ental Assessment	Matagorda Ship Channel
	Appendix F
Public Notice Comments a	and Responses

Final Environmental Assessment

PUBLIC NOTICE NO. GUAD-M-2

DRAFT ENVIRONMENTAL ASSESSMENT MATAGORDA SHIP CHANNEL

Exhibit 2. Tidal Flood flow currents in Lavaca Bay. Adapted from Moffatt and Nichol (2006).

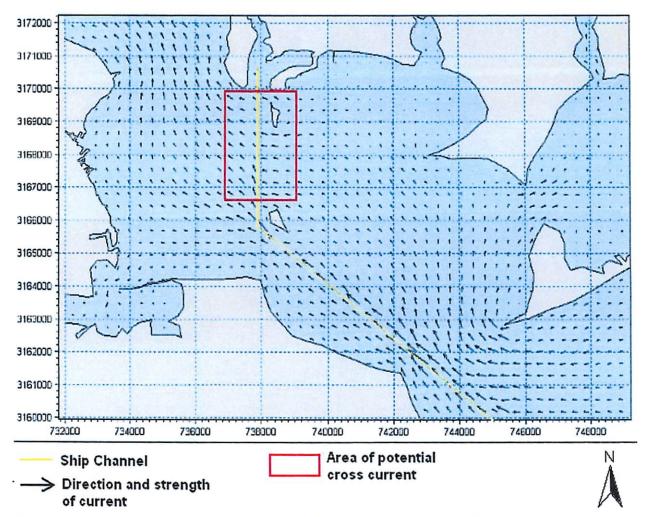
According to Figure 35 on page 51 of the RSM, the area with the greatest sediment accumulation is Reach 1, which is adjacent to PAs 17, 18, and 19. Studies conducted in preparation of the MSCIP-FEIS indicate that the potential cross current affecting this part of the channel would be perpendicular to the channel, while the cross current along Reach 2 (which is adjacent to PAs 14, 15, and 16) would be parallel to the channel (from Volume II, Exhibit 2, attached). Therefore, it is not clear how the relocation of PA 14, PA 15, and PA 16 will relieve sedimentation in Reach 1. In fact, the MSCIP FEIS included the elimination of PAs 14, 15, 16, and 17, the expansion of PAs 18 and 19 into a larger, contained placement site and creation of additional contained placement areas along with beneficial use of material along eroding shorelines (from Volume II, Exhibit 13, attached). TPWD supports the beneficial use of contained dredge materials in creating habitat and protecting infrastructure.

1) BOB's response to THC comment regarding 3 anomalies (illustrated below) not recommended for avoidance:

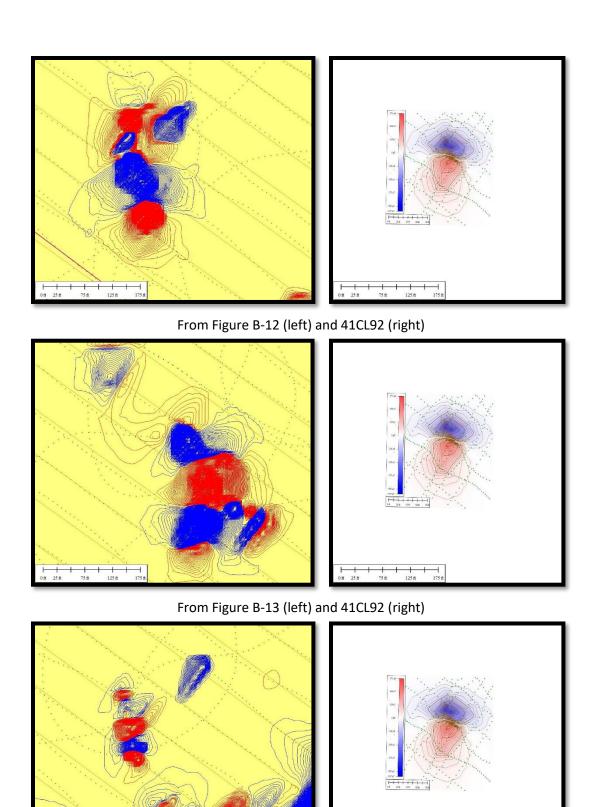
The review staff, led by State Marine Archeologist Amy A. Borgens has reviewed the additional information submitted by BOB Hydrographics in response to a THC letter request dated June 13, 2017. Thank you for clarifying the factors influencing your assessment of the three complex magnetometer targets that were not recommended for avoidance in the draft report. We concur with your original recommendations as presented in the report findings that only anomalies 1-6 be avoided (by the state mandated 50 m) by the proposed work.

The three anomalies that were not recommended and were subject to the THC query (letter dated June 13, 2017) might have been recommended by other investigator using more conservative interpretative models, such as Pearson's amplitude/duration model, if your interpretative model was not applied. Though the THC understands the reasoning behind your recommendations, we ask that the more detailed information provided in your response letter dated June 13, 2017 be incorporated into the draft report so that it is clear to all audiences why these were not recommended, especially since they were subject to a more intensive close-order survey. To expedite this report review, it is recommended the draft be revised and submitted electronically via e-TRAC to review this added content, before proceeding towards finalization of the report.

I've provided color illustrations below of the three anomalies questioned by the THC. Beside each (at the same scale) is an illustration of the smallest verified shipwreck anomaly that I'm aware of, from 41CL92. I appreciate the THC's comments regarding these anomalies. Amy is correct that there is some similarity in appearance between the three unidentified anomalies shown below and some verified wreck anomalies. The examples she cited are anomalies from *Selma*, *City of Waco*, and *Utina*.

In my experience, a wreck in this setting should have an anomaly shaped and oriented reasonably like that of 41CL92, exhibiting a negative pole (blue contours) north of a positive pole (red contours) regardless of whether the hull is comprised of wood or ferrous metal. The ship wrecked at 41CL92 had a wooden hull; however, several ferrous examples, from the Galveston North Jetty, are attached to the end of this document, showing that ferrous hull anomalies may look substantially similar to 41CL92. Some wreck anomalies, in similar latitudes, may exhibit an additional, much smaller-amplitude, positive magnetic peak north of the main negative pole. I've only observed this on vessels with ferrous hulls, presumably due to the high amplitude of their anomalies. This can be seen clearly in the *City of Waco* example cited by Amy in her letter, as well as in figures 11, 12 and 15 from the Galveston North Jetty below. Additional, smaller magnetic poles are possible if other debris is deposited near a wreck, including superstructure separated from the main wreckage. This is what we believe happened with the *Utina* (see illustration in THC's letter).

None of the three unidentified anomalies in question have simple dipoles, such as 41CL92; however, all three contain a dipolar pattern (with a negative pole north of a positive pole) embedded within a more complex pattern. When presented with this situation, I believe it is a judgment call on the part of the archaeologist as to whether the anomaly might be associated with a wreck or not. The additional poles, outside of the north-south dipole pattern discussed above, must be accounted for. None of the additional poles fit the pattern typical of ferrous hulls (see attached Galveston North Jetty examples; also, *City of Waco*, MMS 773, and MMS 323 in Figure 2a below) in which a much smaller positive pole occurs north of the main dipole. The large north-south dipole on the Figure B-12 example comes the closest to matching the 41CL92 model used for interpretation. The other two examples, in my opinion are poorer matches for 41CL92.
